Quality Audit
Inclusive of Stage 1 Road Safety Audit
for
PROPOSED RESIDENTIAL DEVELOPMENT
AT
THE GRANGE
BREWERY RD, STILLORGAN, DUBLIN 18

Date: August 2019

Reference: RSM/MOB/080719/GRANGE-QA1

Figure 71: Connectivity to Footways on the N11 Unclear

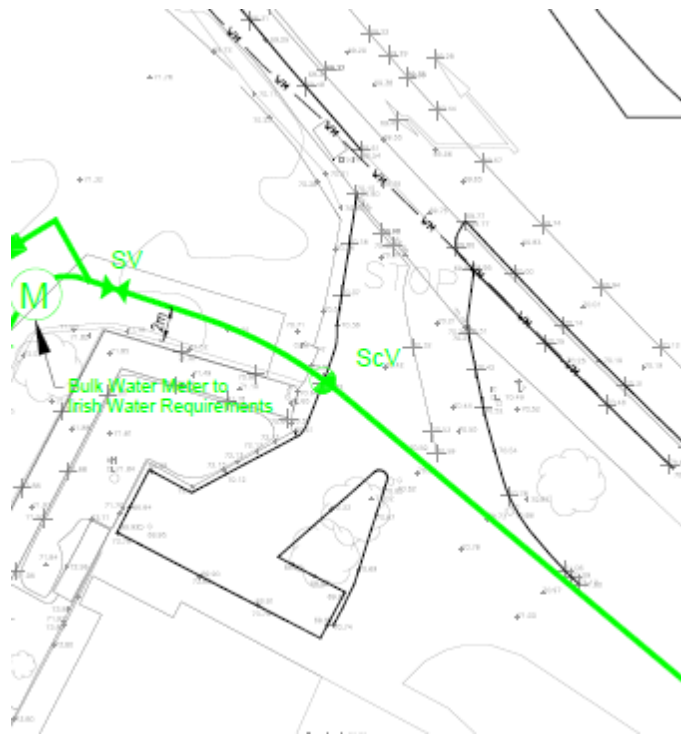
- The potential for poor Intervisibility was also noted at some locations within the site, including at the tie-ins on the N11, where pedestrians egressing the site will be brought directly out into a junction where there is no current footway provision, and where the risk of conflict with turning and waiting vehicles will be higher, as shown in figure 71. There are a number of locations throughout the site where landscaping is proposed in close proximity to crossing points and potential desire lines, with examples shown in figures 74-76. Insufficient intervisibility can increase the risk of pedestrian/vehicular conflict.

Figure 77: Connectivity at ramp unclear

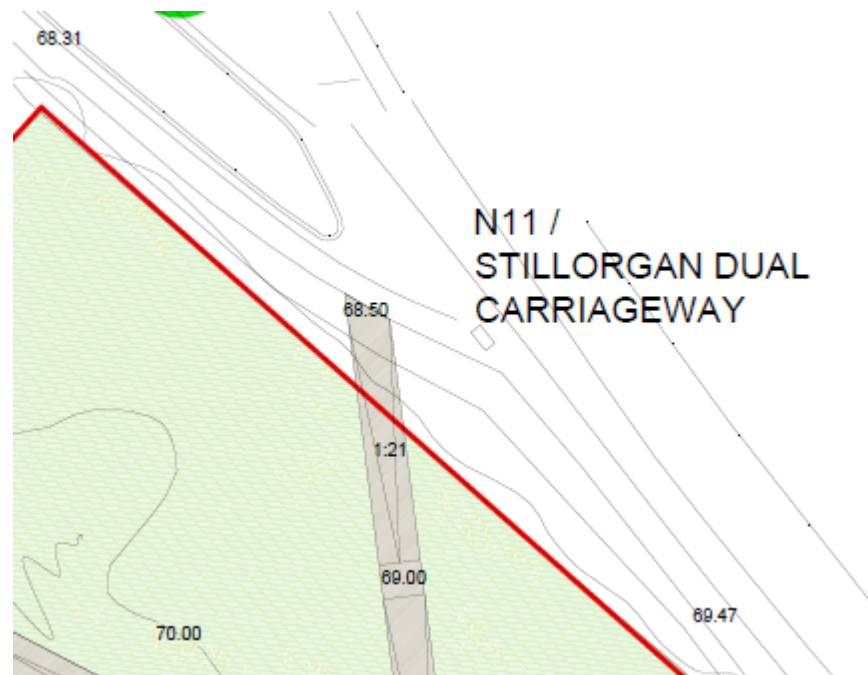
- Continuity and connectivity to the northwest and northeast of the site is unclear, and no provision has been made for desire lines to cross the carriageway to and from the bus stop on the opposite side of the N31 to the site.

Figure 78: Lack of tactile paving across internal access points

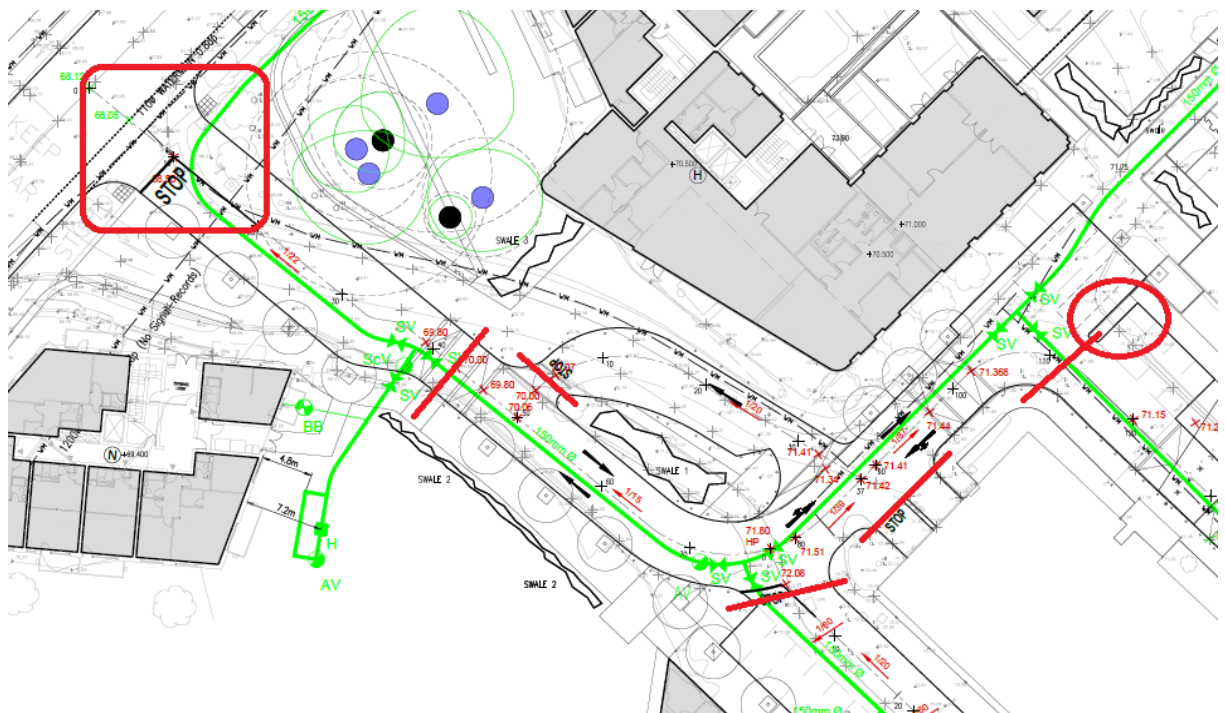
Design plans show steps at a number of locations throughout the site where there is no provision for tactile paving at the top and bottom to alert visually impaired pedestrians to the presence of the hazards. Ramps have also been provided at some locations, however the ramps widths appear narrow, and the provision for ramped access for wheelchair users, buggy users or other mobility impaired pedestrians throughout the site is not clear from the plans supplied. Tactile paving has been provided across the mouth of the reconfigured access junction, however is absent at crossing points at other locations throughout the site, as highlighted in figure 78.

Figure 80

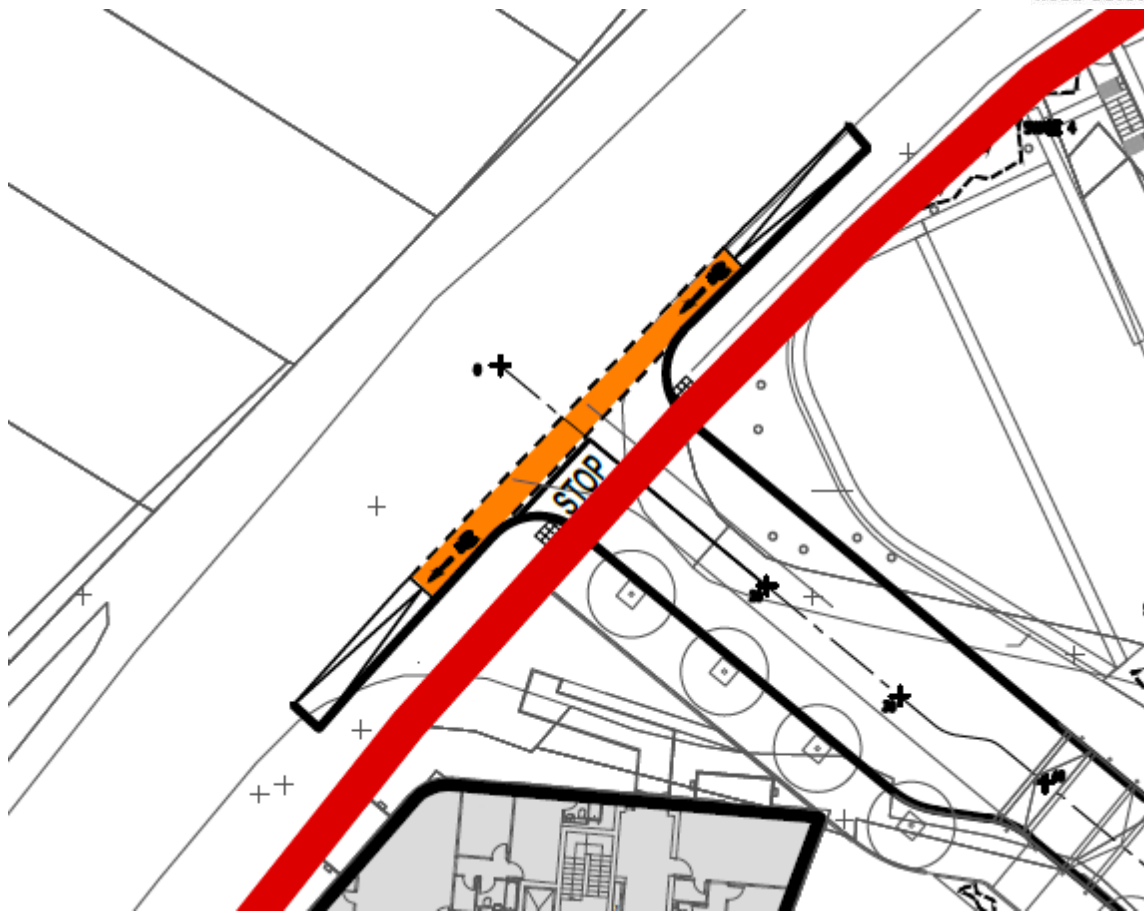
- Provision has been made for coloured surfacing and road markings for the continuity of the off road cycle track across the mouth of the access junction, as shown in figure 80, however the connectivity of the facility on the western side does not appear to line up with the existing kerbline.
